Product Change Notification

Product:	RF Cable Assembly, I-Pex MHF Plug to SMA Bulkhead Jack to 1.13mm Cable
Originator:	Vincent Ji
PCN Number:	PC-CA348-016

Series Numbers Concerned:	CABLE 348 RF Revision 1.5 to Revision 1.6
Issue Date:	30 November 2022
Pages:	2

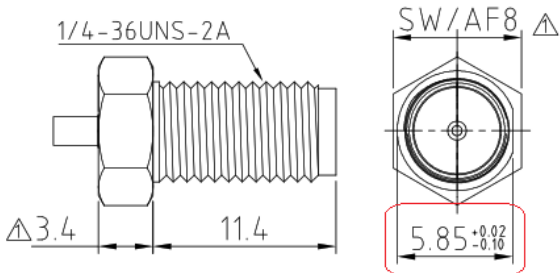
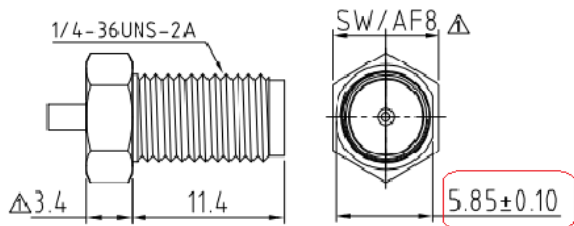
- Impact :**
No impact on function or performance.
1. Tolerance changes see below:
 - a. From 5.85 +0.02 / – 0.1mm. To 5.85 +/- 0.1mm.
(The same panel cut-out dimensions still apply)

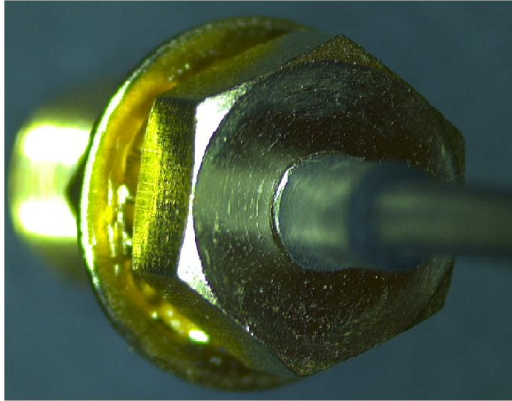
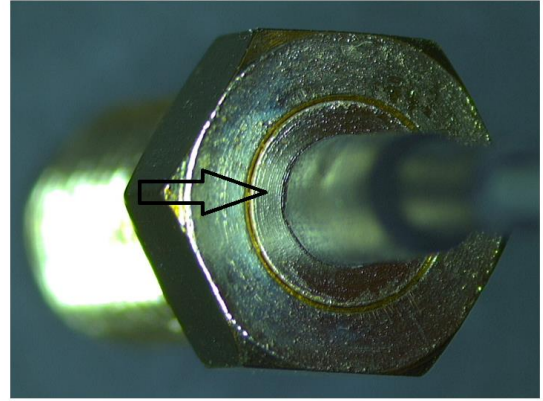
2. Visual differences to the rear of SMA connector. See below
